**ADDENDUM NO. 7
A NEW BUILDING REPLACEMENT FOR:
FINKLEA FIRE STATION #6
HORRY COUNTY, SOUTH CAROLINA
HORRY COUNTY PROJECT NUMBER 2023-24-091
PMH PROJECT NO. 24002
May 22, 2025**

THIS ADDENDUM CONTAINS:

Sketch No. P1

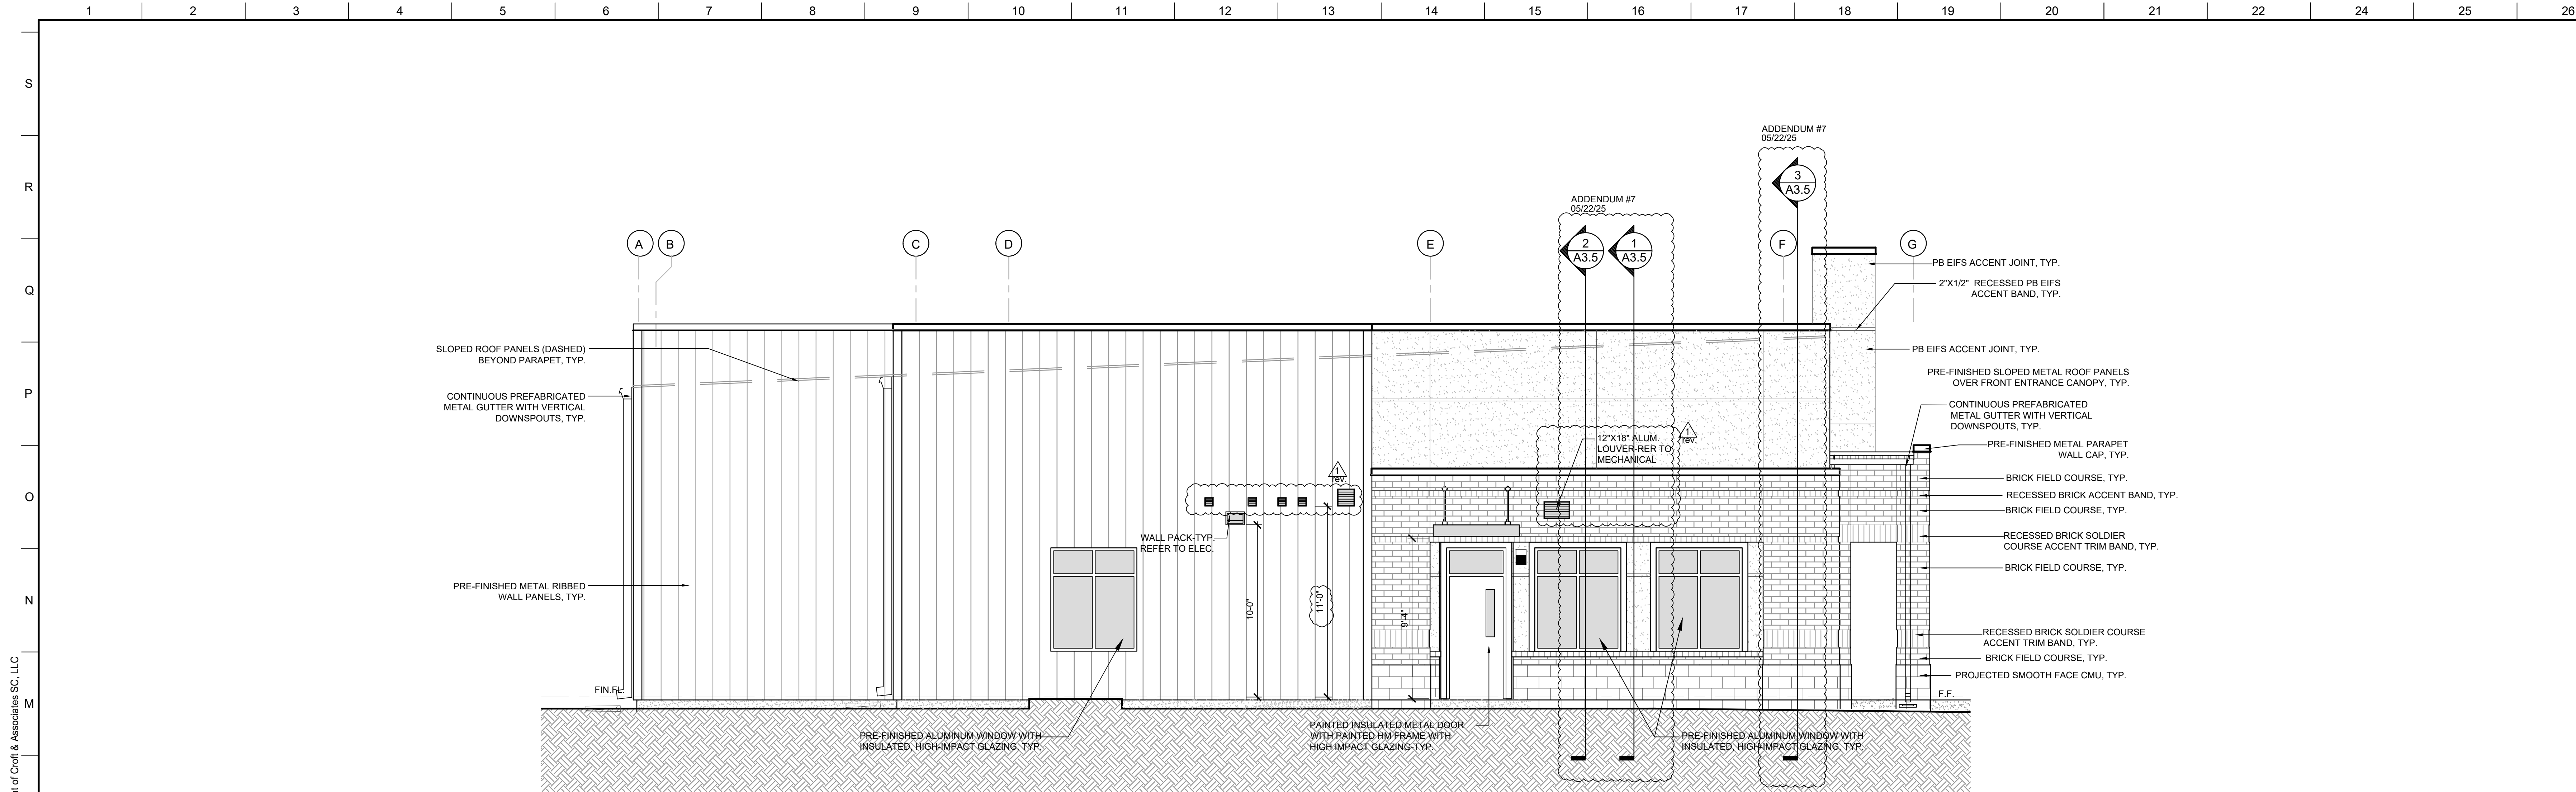
Q12. THE CURRENT PLUMBING FIXTURE SCHEDULE DOES NOT HAVE SPECIFICATIONS FOR THE P-3 SINK LOCATED IN ROOM WH/STO 118. PLEASE PROVIDE SPECIFICATIONS FOR THE P-3 SINK.

A12. The P-3 Lavatory is as issued with the original Construction Documents. The CAD drawing layer was inadvertently turned off during a revision. Attached, please find Sketch No. P1 showing the P-3 information.

- A. Contractor's attention is directed to Schedule of Plumbing Fixtures & Specialty Equipment, Fixture P-3. Contractor is advised to omit this fixture in its entirety and replace with Fixture P-3 as shown in Sketch No. P1 (attached herewith) consisting of 1 page dated 05-22-25. For clarification, the CAD drawing layer was inadvertently turned off so information was not shown.

SHEET NO.
A2.1

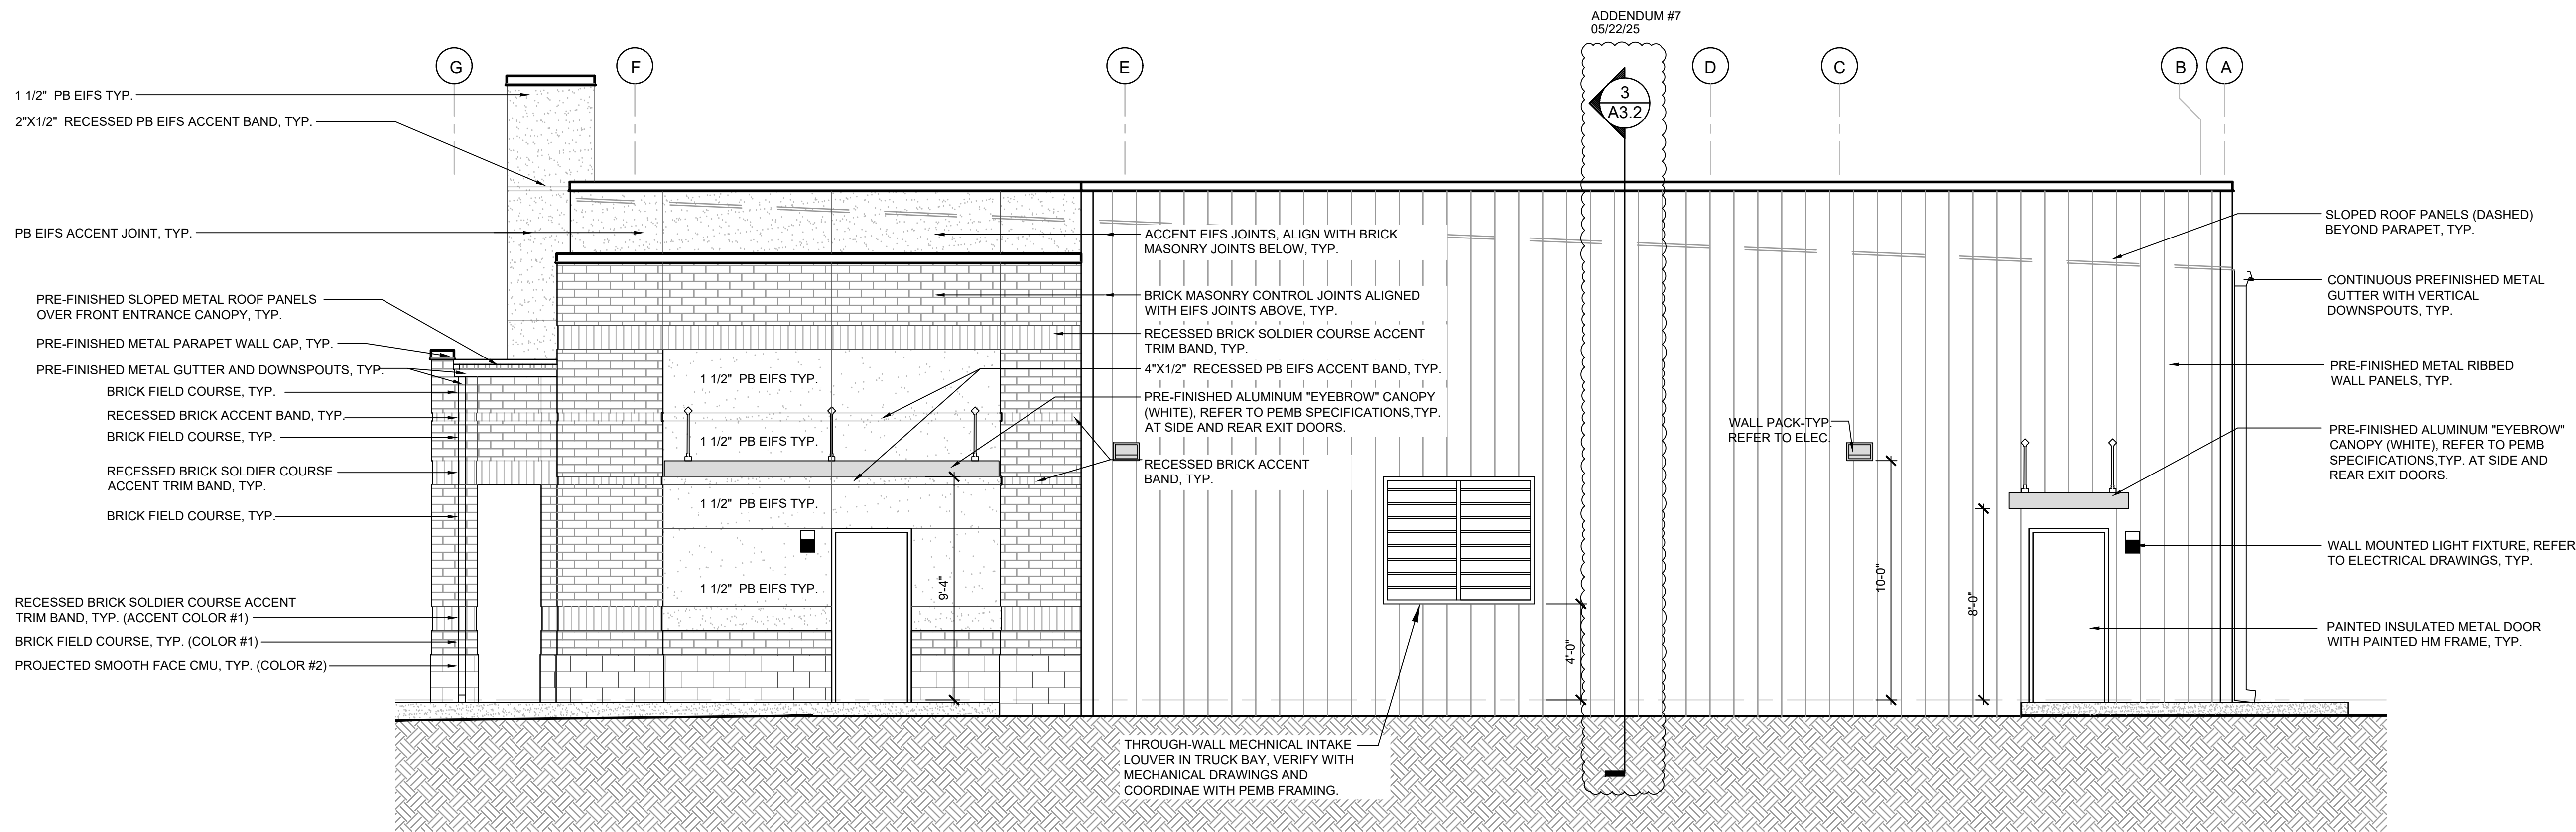
Q34C. FOR THE BASE BID, ARE PEMB WALL GIRTS REQUIRED AT FRAME LINE 7 WHERE PEMB VERTICAL EXTERIOR WALL PANELS ARE TO BE INSTALLED OR IS THE INTENT FOR THE VERTICAL EXTERIOR WALL PANELS TO ATTACH OVER STUDS PER WALL LEGEND 5?

Q35A. NEED WALL SECTIONS AND DETAILS ALONG COLUMN LINES 1 AND ALONG COLUMN LINE 7 (COLUMN LINE 8 FOR ALT 1). WALL LEGEND DETAILS DO NOT MATCH WALL SECTION DETAILS AND THEY ALSO DO NOT MATCH THE STRUCTURAL DETAILS FOR METAL STUD FRAMING VERSUS PEMB STRUCTURE AND SUBSTRATES ON THESE WALLS. I MAINLY NEED THE DETAILS AT THESE COLUMN LINES BETWEEN COLUMN LINES E AND F. HOWEVER, ON A1.0 COLUMN LINE 7 BETWEEN E AND A THE WALL TAG SHOWS 5(SIM) BUT ON A1.1 ON COLUMN LINE 8 IT SHOWS WALL TAG AS 2.

A34C. Refer to revised Sheet A2.1, Details 1/A2.1 & 2/A2.1 - Wall Sections have been indicated at column line 7 between E and A. These same wall section tags apply to Alternate #1 also.

Refer to revised Sheet A2.1, Details 1/A2.1 & 2/A2.1 - Wall Sections have been indicated at column line 7 between E and A. These same wall section tags apply to Alternate #1 also.

- A. Contractor's attention is directed to SHEET A2.1 – ELEVATIONS BASE BID AND ALTERNATE #1. Contractor is advised to omit this sheet in its entirety and replace with SHEET A2.1 – ELEVATIONS BASE BID AND ALTERNATE #1 (attached herewith) consisting of 1 page dated May 22, 2025 for wall sections at Details 1/A2.1 and 2/A2.1.
